Project: Bridgeport, Fairfield and Westport: New Haven Mainline-Catenary Replacement Bridge & Roadway Reconstruction

0090059-001
8 x 14 Bridge Plates

Shop Drawing Review

8'-0" x 14'-0" BRIDGE PLATES
WITH 42" HIGH REMOVABLE 2-LINE RAILS

2/2 ELEVATION VIEW
8'-0" x 14'-0" BRIDGE PLATE
SCALE: NTS

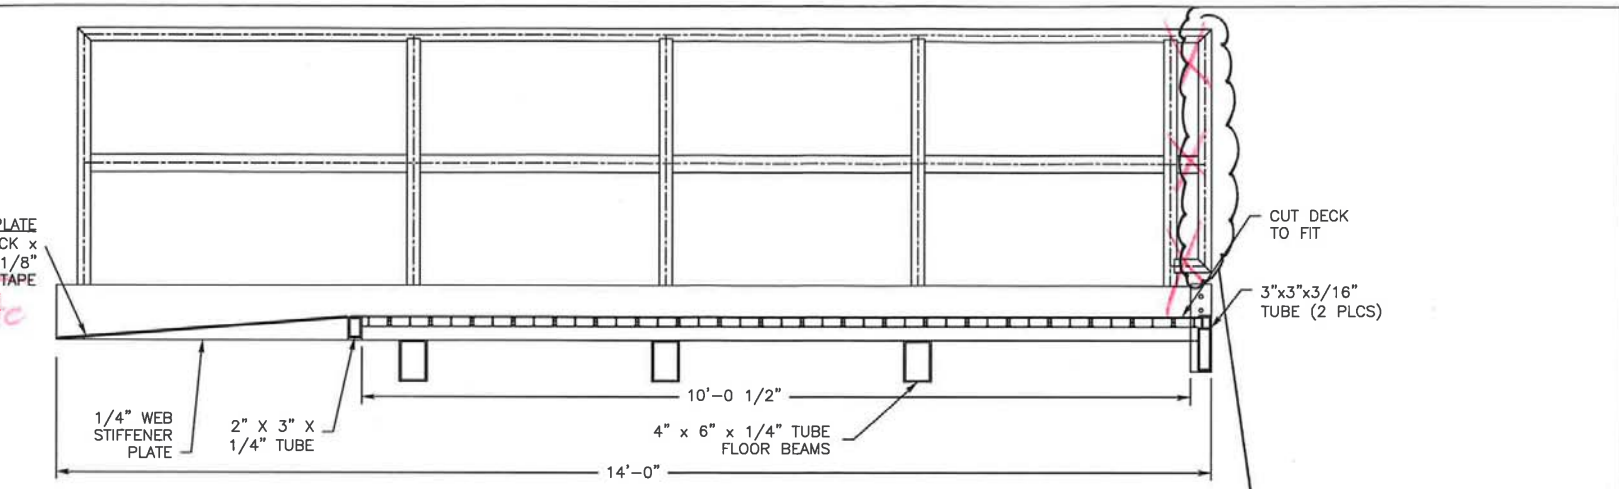
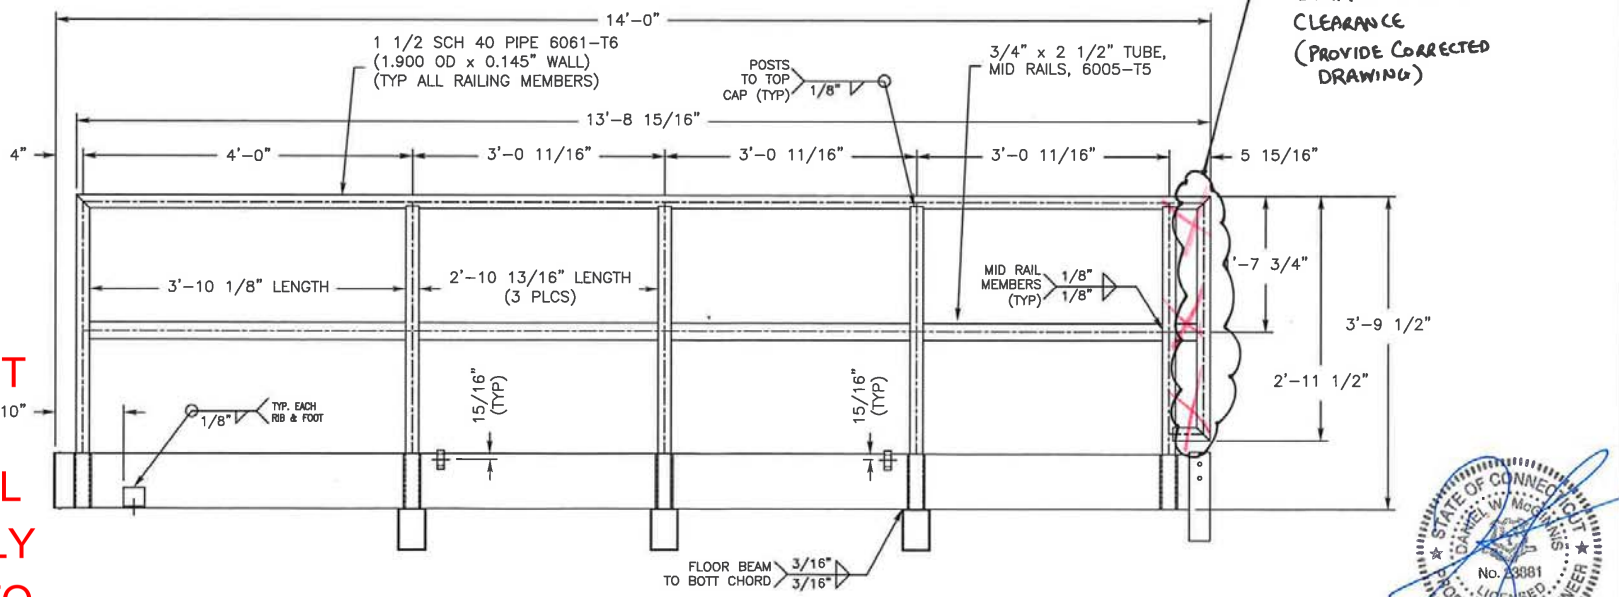
METRO NORTH TO PROVIDE RAILING SETBACK DISTANCE FOR TRAN CLEARANCE (PROVIDE CORRECTED DRAWING)

1/5 DETAIL VIEW
LEG DETAIL
SCALE: NTS QTY: 2 NEEDED

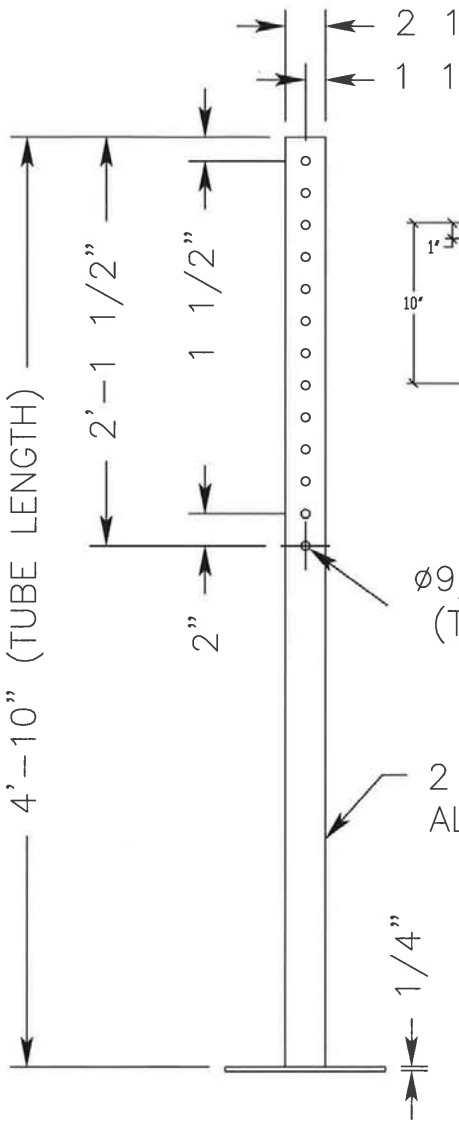
6" of Bearing Read. on 10" plate
